**Development Application: 413-415 Sussex Street and 82-84 Dixon Street,
Haymarket - D/2020/1386**

File No.: D/2020/1386

Summary

Figure 27: Proposed architectural roof feature

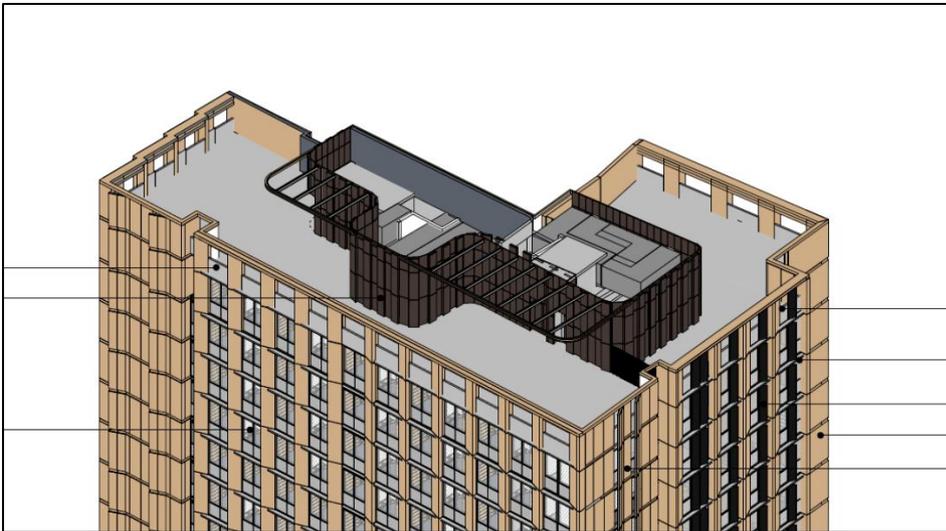
51. The proposal meets the requirements of clause 5.6 of the LEP outlined above including the requirements of clause 5.6(1)(b) in that servicing including plant, lift motor rooms and fire stairs are fully integrated into the design of the roof feature.

Figure 28: Cross section and 3D image detailing proposed height above 55m

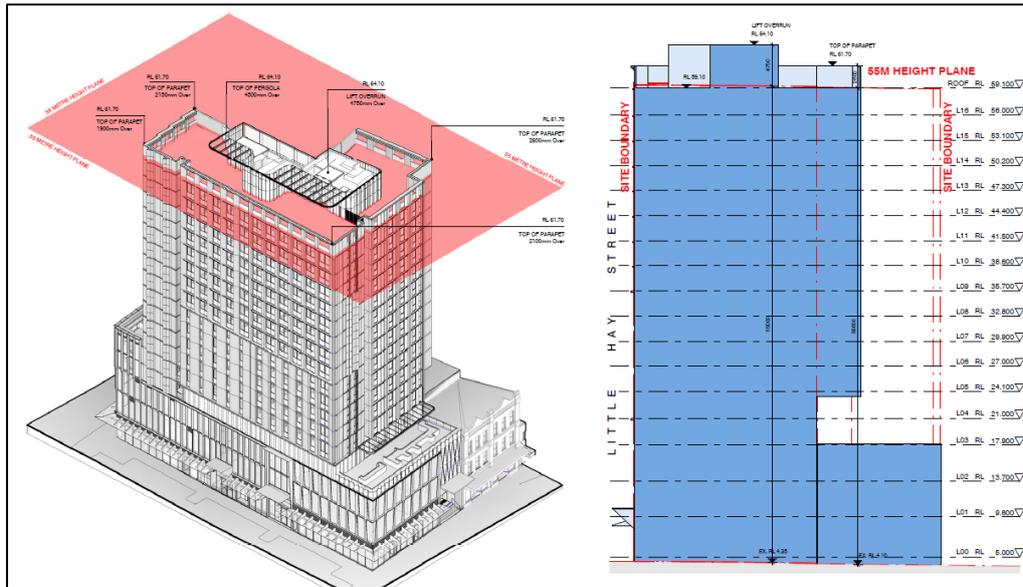
52. A clause 4.6 variation request has been submitted to justify the height exceedance above the 50m height standard. Refer below.

Figure 29: Height above 50m

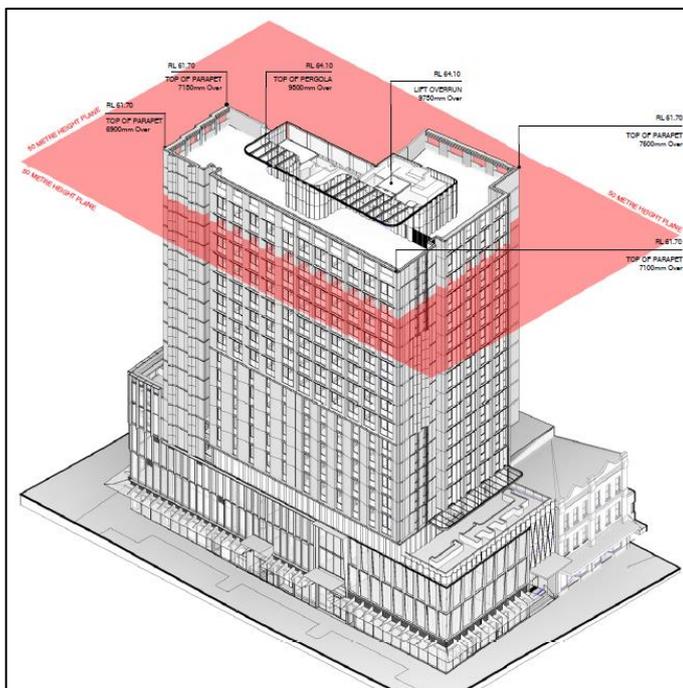
57. The site is subject to a maximum height control of 50m.
58. The proposed development has a maximum height of 59.75m, exceeding the Height of Buildings development standard by a total of 9.75m and resulting in a 19.75% variation from the development standard.

Figure 30: Cross section detailing proposed height above 50m

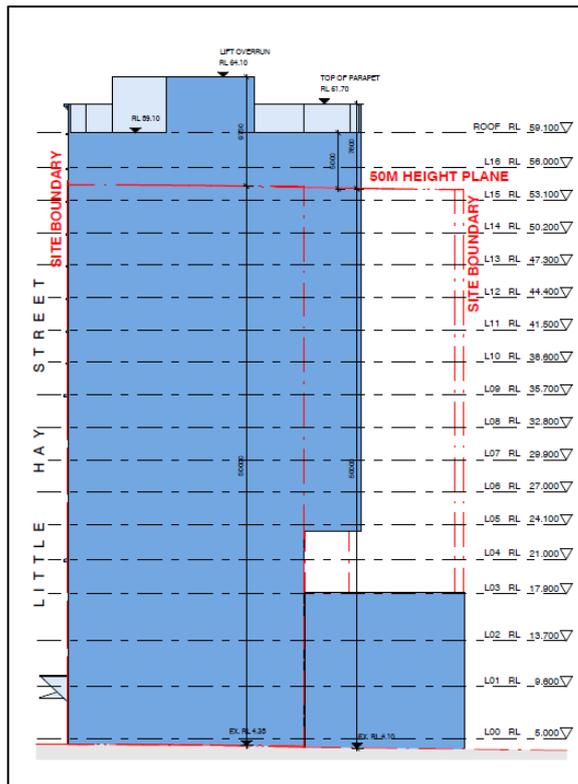
59. A written request has been submitted to Council in accordance with Clause 4.6(3)(a) and (b) of the Sydney LEP 2012 seeking to justify the contravention of the development standard by demonstrating:
- (a) That compliance with the development standard is unreasonable or unnecessary in the circumstances of the case
 - (b) That there are sufficient environmental planning grounds to justify contravening the standard
 - (c) The proposed development will be consistent with the objectives of the zone
 - (d) The proposed development will be consistent with the objectives of the standard.

Figure 32: Little Hay Street - The original scheme on left with the amended scheme on the right

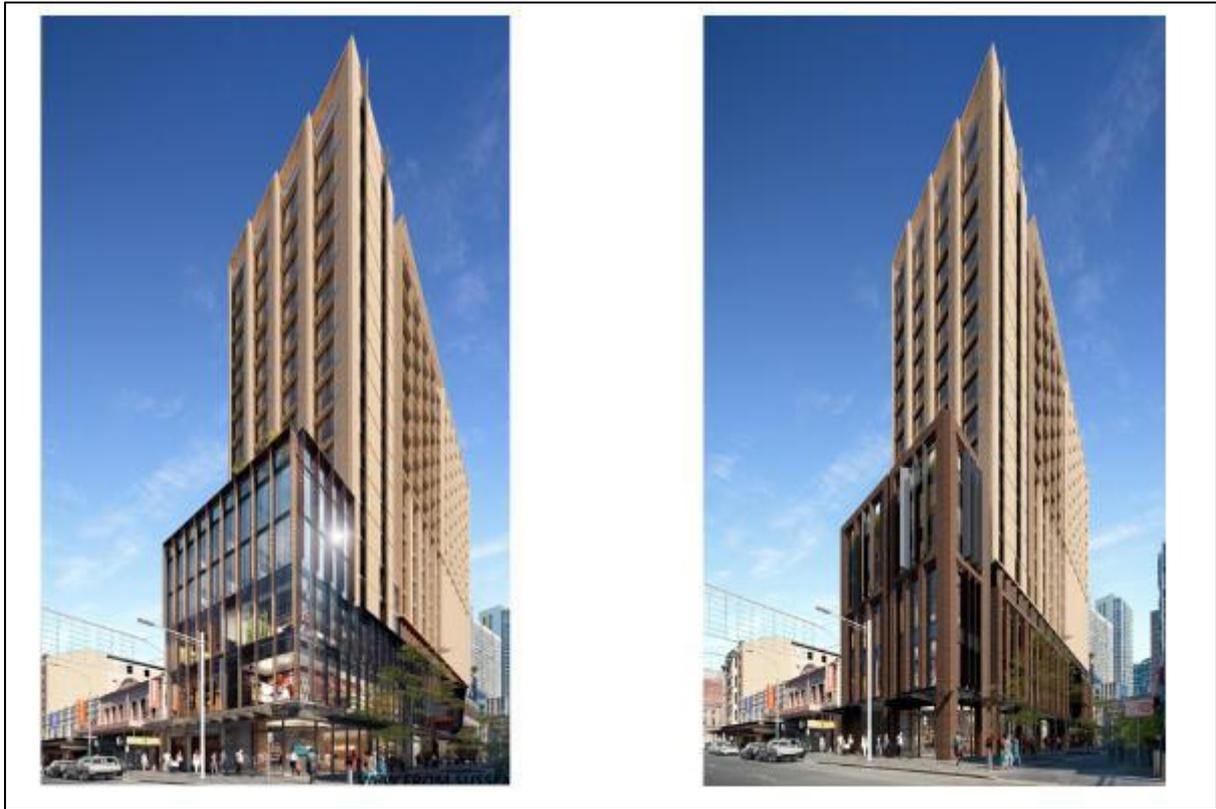
- (h) The incorporation of pre-cast concrete in the blank south facing wall on Sussex Street to provide design articulation.
 - (i) Brick tile has been replaced by real brick construction to the podium and brick inlay precast to the tower.
